# R129 NECK LIMITS: EFFECT OF CHIN-TO-CHEST CONTACT AND POTENTIAL SOLUTIONS

*Submitted by the experts from CLEPA*

*70<sup>th</sup> session of GRSP, 06 – 10<sup>th</sup> December 2021*

## Front impact: Q3 in Booster Seat A

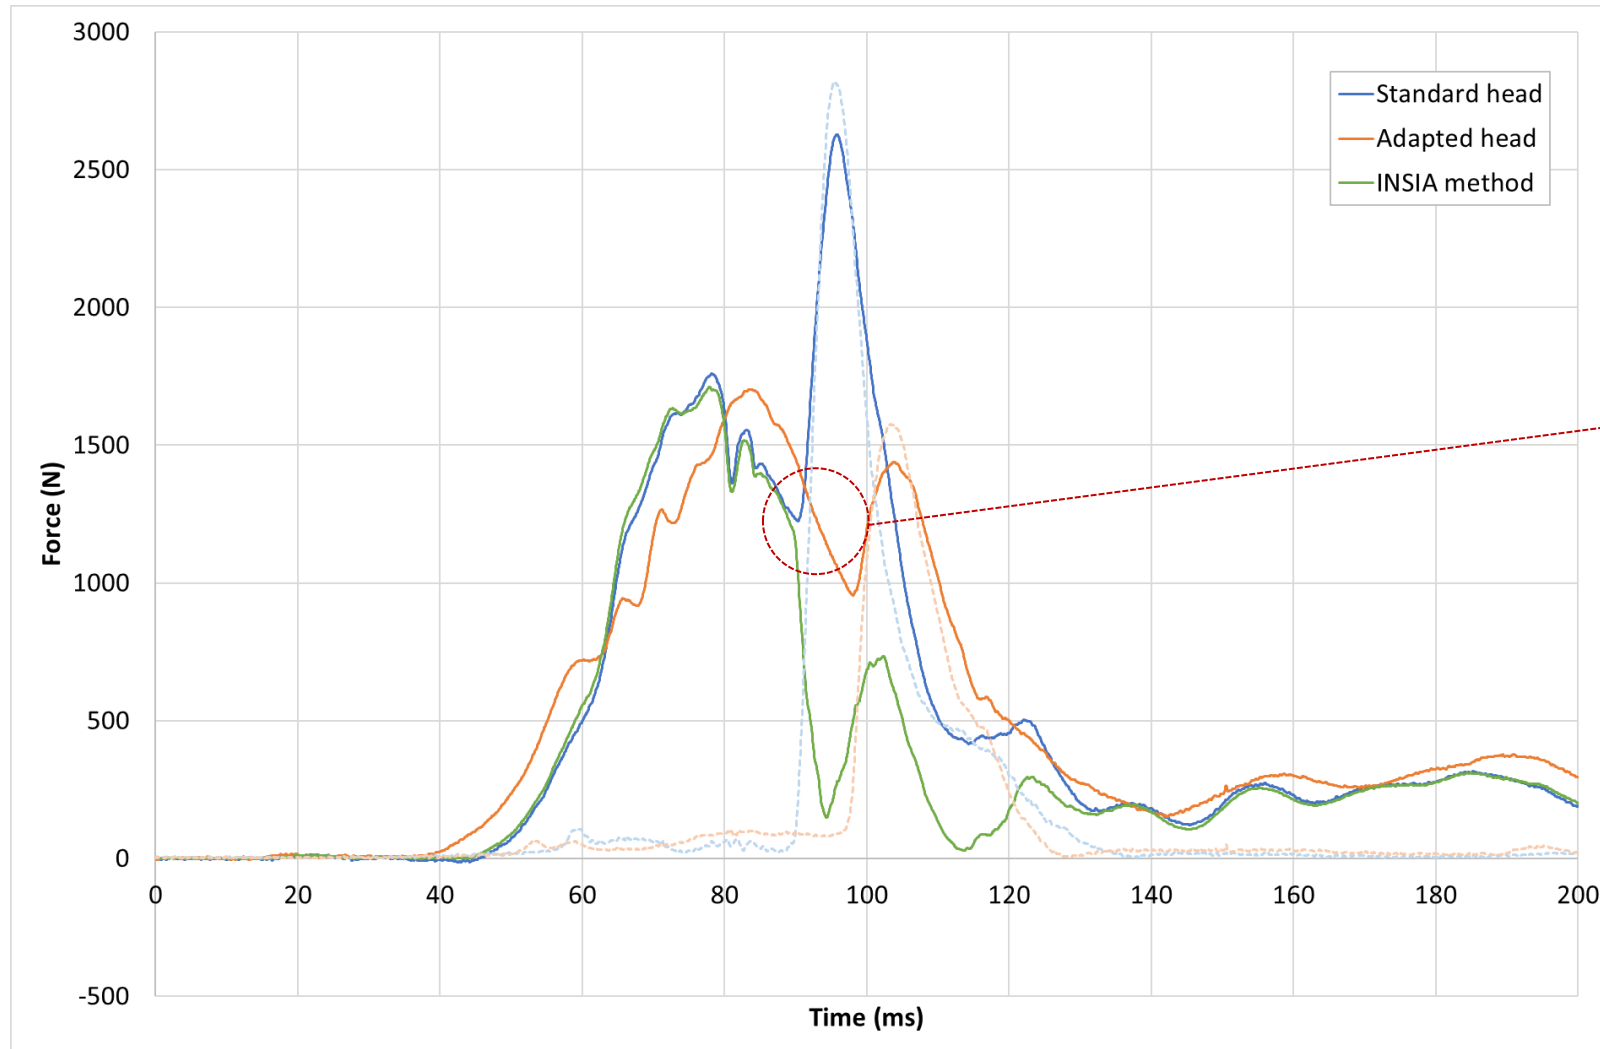
Rapid drop-off in INSIA calculated inertial force seems unrealistic and suggests contact itself can influence vertical head acceleration (and hence this calculated force)

## Front impact: Q3 in Booster Seat B

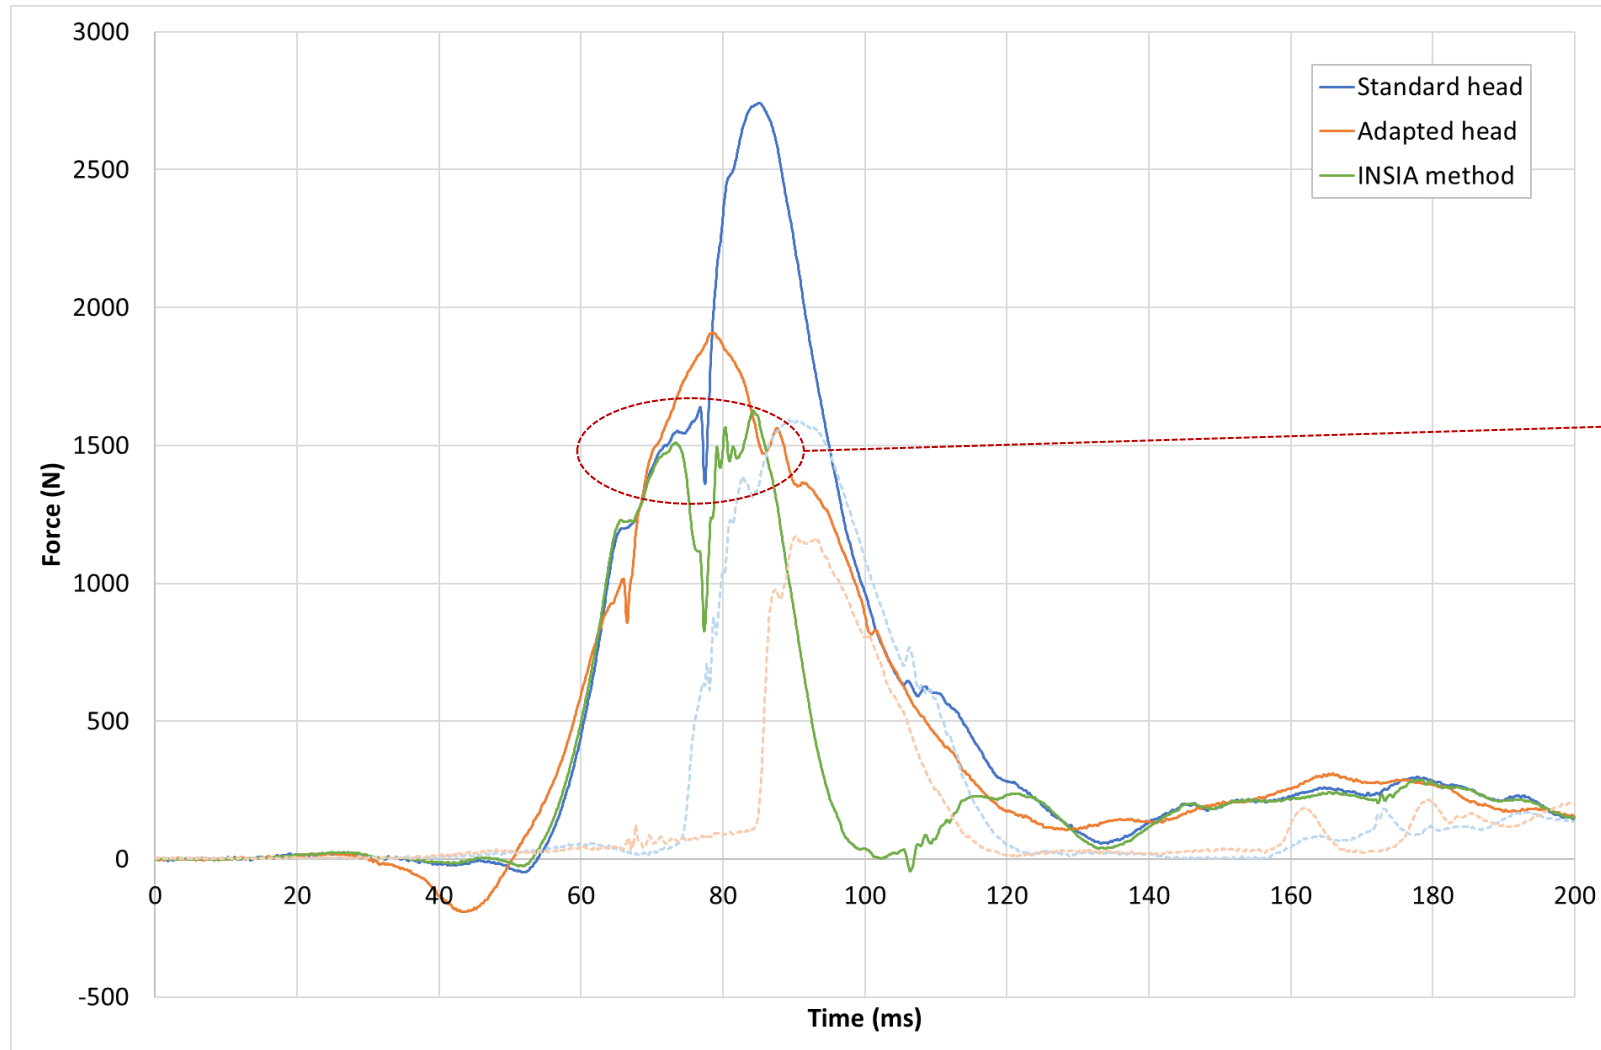
Broad peak duration in INSIA method seems unrealistic and may be masking true inertial force had contact not occurred (as suggested by adapted head with lesser contact)

## Rear impact: Q3 in RF Integral Harness CRS

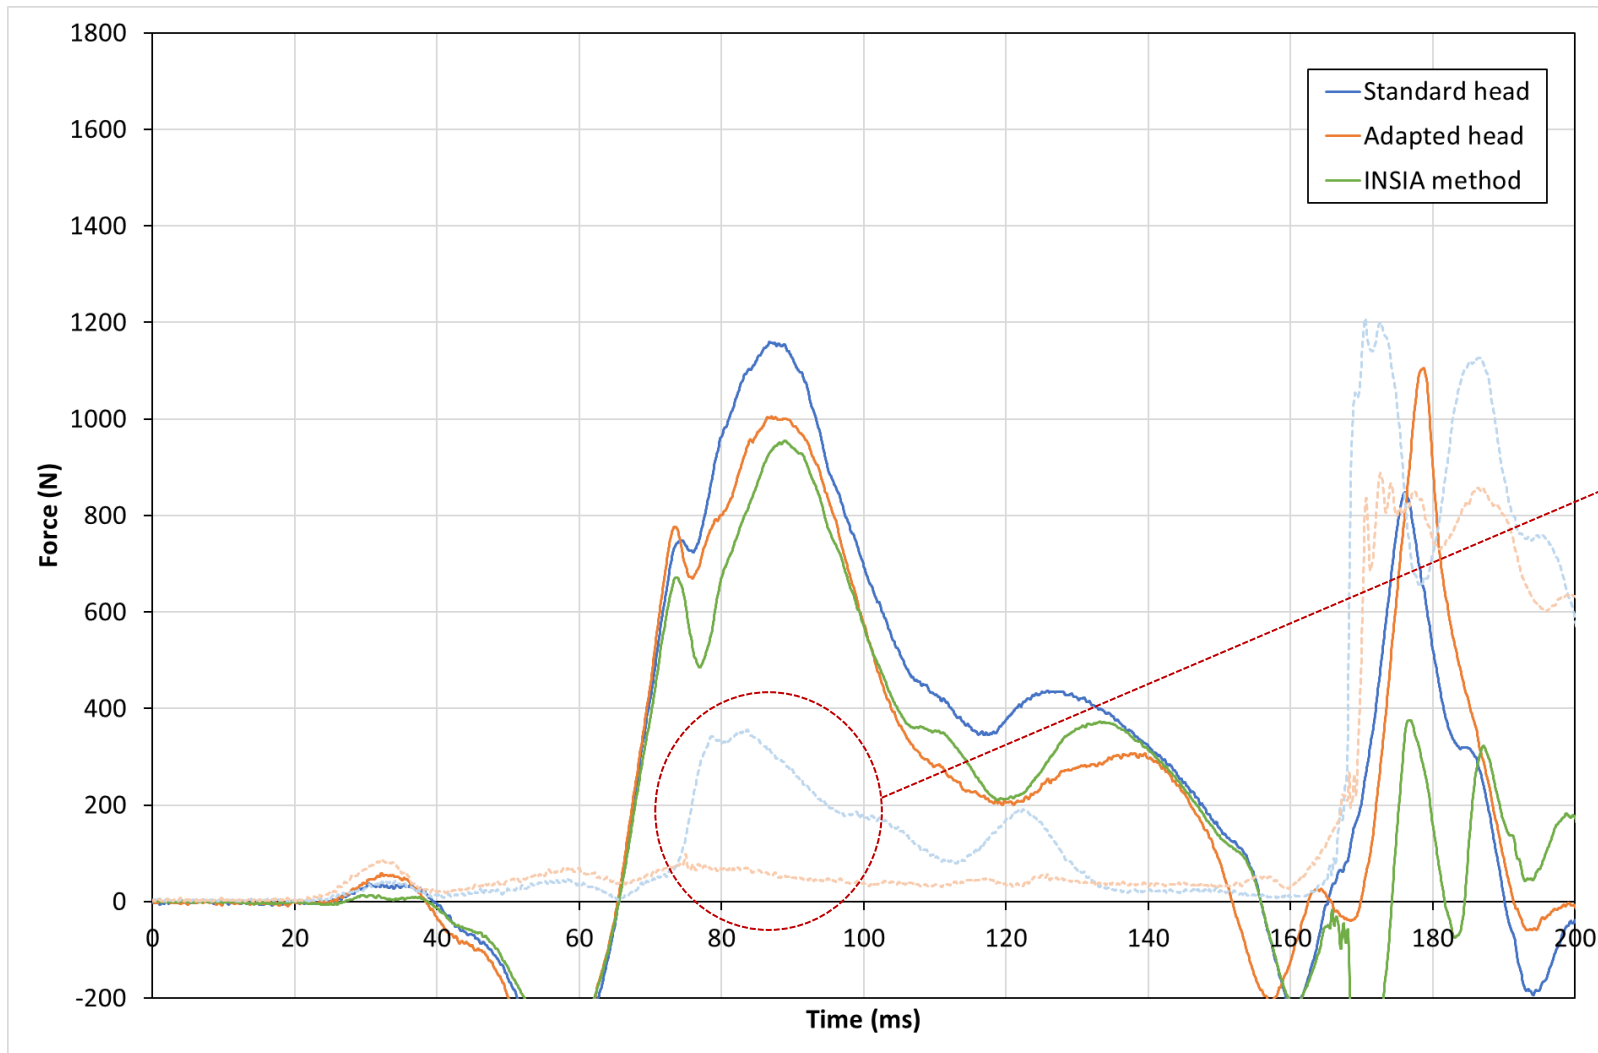
Marginal contact with standard head (i.e. <500 N), reduced to negligible level with adapted head. INSIA method predicts inertial force reasonably well
